Denim Fashions Ltd.

RS-370, CS-727, Sataish, Tongi, Gazipur, 1712

22nd February 2015

Observations

Building 1

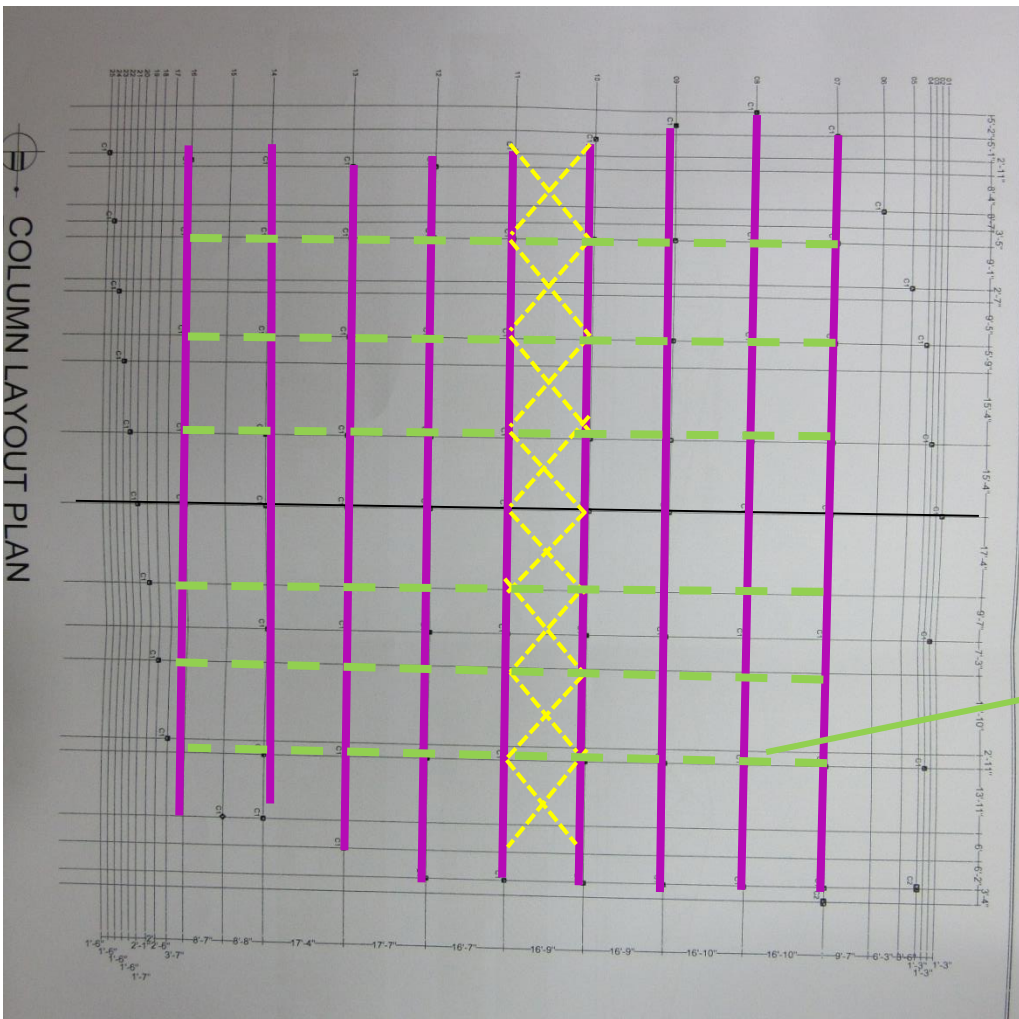
Roof steel trusses seem to be non-engineered

Very poor welds between truss members

The sizes of structural members are very small (L-shapes L50 x 5 to L70 x 7)

Supporting columns are NOT coincident with truss nodes

In general, no vertical truss members at bearing points

Roof steel trusses seemed to be non-engineered

Item No.	Observation	Recommended Action Plan	Recommended Timeline
1	Steel roof appears to be non-engineered	Factory Engineer to carry out an Engineering design check for the Building 1 roof.	Immediate - Now
2	Steel roof appears to be non-engineered	Engineering design check to be completed.	6-weeks
3	Steel roof appears to be non-engineered	Make structural alterations as advised by Factory Engineer.	6-weeks
4	No stability bracing at roof level	Factory Engineer to review the stability of the steel roof structure with consideration of as-constructed joints, uplift forces, lateral loads and global stability.	Immediate - Now
5	No stability bracing at roof level	Factory Engineer to advise on any necessary alterations.	Immediate - Now
6	No stability bracing at roof level	Make structural alterations as advised by Factory Engineer.	6-weeks
7	No structural connections between steel trusses and purlins	Factory Engineer to review the design of the purlin connection to the trusses, with respect to the provision of engineered support points and withstanding uplift forces and lateral loads.	Immediate - Now

Building 2

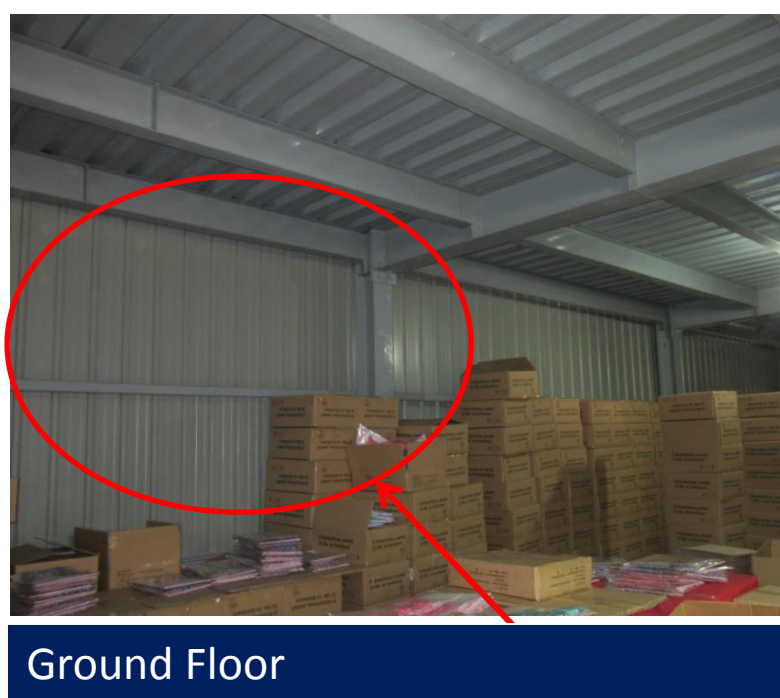
No vertical stability system in longitudinal direction

No vertical
bracing

No vertical stability system in longitudinal direction

Item No.	Observation	Recommended Action Plan	Recommended Timeline
10	Bearing of trusses on columns seems to be non-engineered	Factory Engineer to review the bearing of the steel roof trusses on the columns, with respect to the provision of engineered support points and withstanding uplift forces and lateral loads.	6-weeks
11	Bearing of trusses on columns seems to be non-engineered	Factory Engineer to advise on any necessary alterations to steelwork.	6-weeks
12	Bearing of trusses on columns seems to be non-engineered	Factory Engineer to advise on any necessary alterations to steelwork.	6-months
13	No vertical stability system in longitudinal direction	Factory Engineer to investigate the stability of the building in the longitudinal direction, and advise on any necessary alterations.	6-weeks
14	No vertical stability system in longitudinal direction	Carry out structural alterations as advised by Factory Engineer.	6-weeks

Building 2

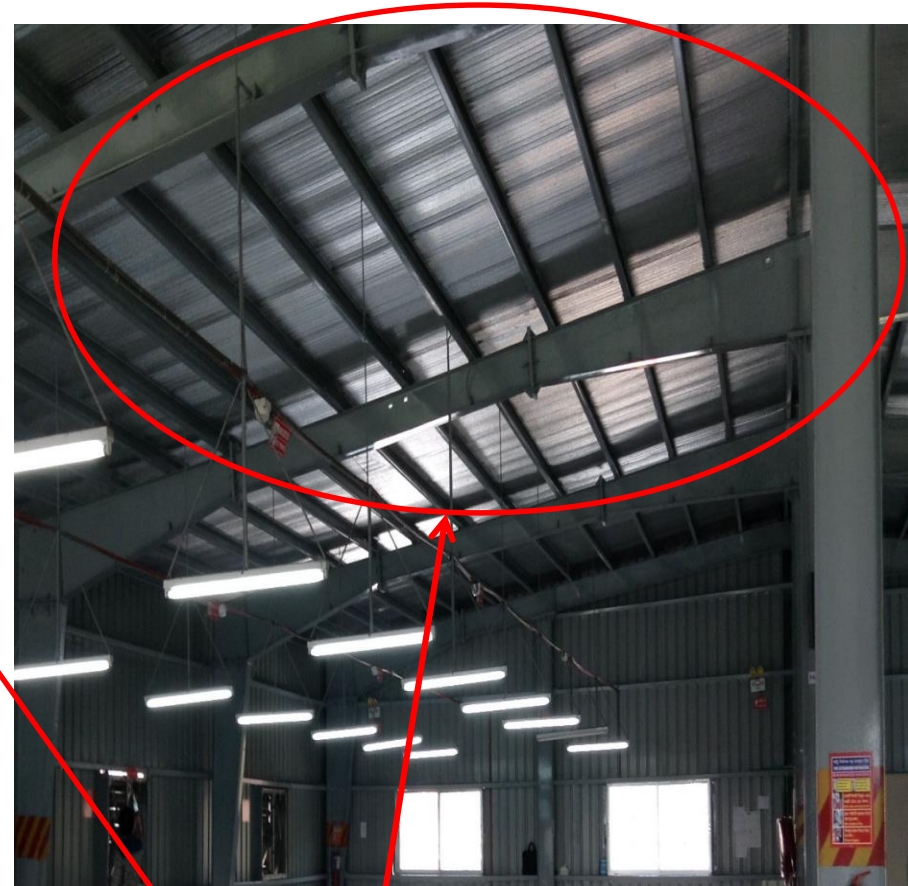
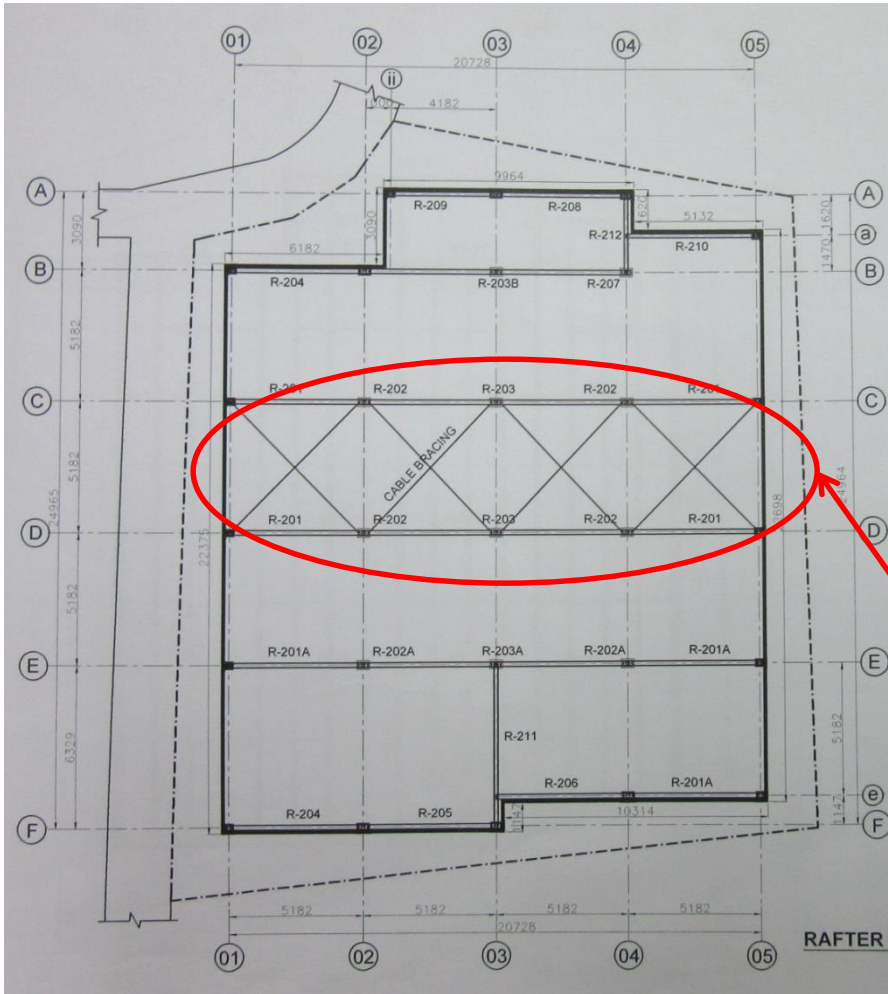
Roof bracing is missing

Bracing shown on drawing
but missing from roof

Roof bracing is missing
Building 2

Item No.	Observation	Recommended Action Plan	Recommended Timeline
15	Roof bracing is missing	Factory Engineer to assess the lateral stability at roof level with respect to the transfer of lateral loads to the vertical structure.	6-weeks
16	Roof bracing is missing	Factory Engineer to advise on any necessary alterations to the steelwork in order to achieve lateral stability.	6-weeks
17	Roof bracing is missing	Carry out structural alterations as advised by Factory Engineer.	6-weeks
18	Semi-rigid connections at "rigid" moment frame corners	Factory Engineer to assess the stability system in cross direction of the building, taking into consideration the as-built details at the moment frame connections.	6-weeks
19	Semi-rigid connections at "rigid" moment frame corners	Factory Engineer to advise on any necessary alterations to the steelwork in order to achieve lateral stability.	6-weeks
20	Semi-rigid connections at "rigid" moment frame corners	Carry out structural alterations as advised by Factory Engineer.	6-weeks

Building 2

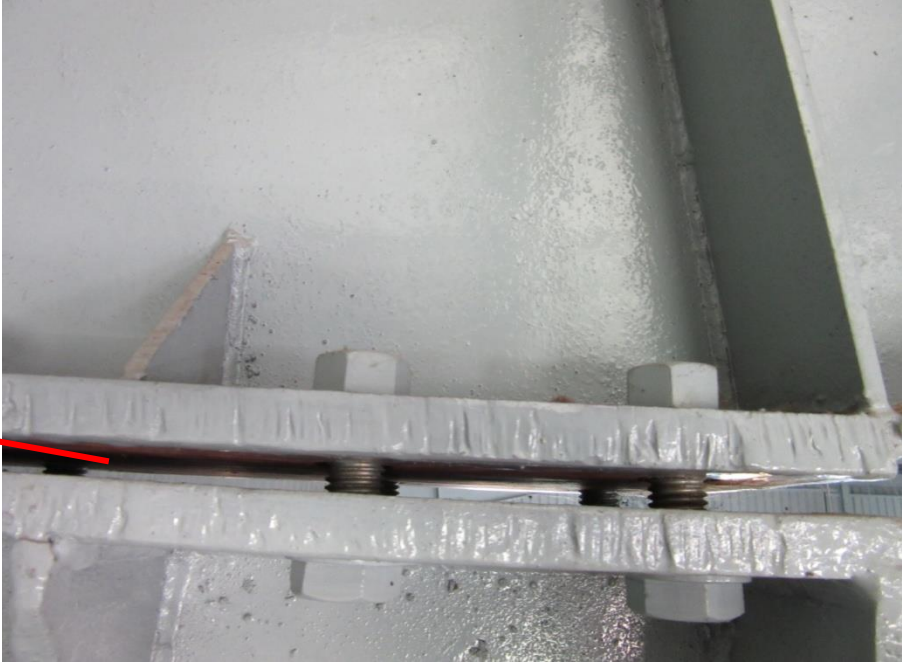
Semi-rigid connections at “rigid” moment frame corners

Semi-rigid connections

Semi-rigid connections at "rigid" moment frame corners
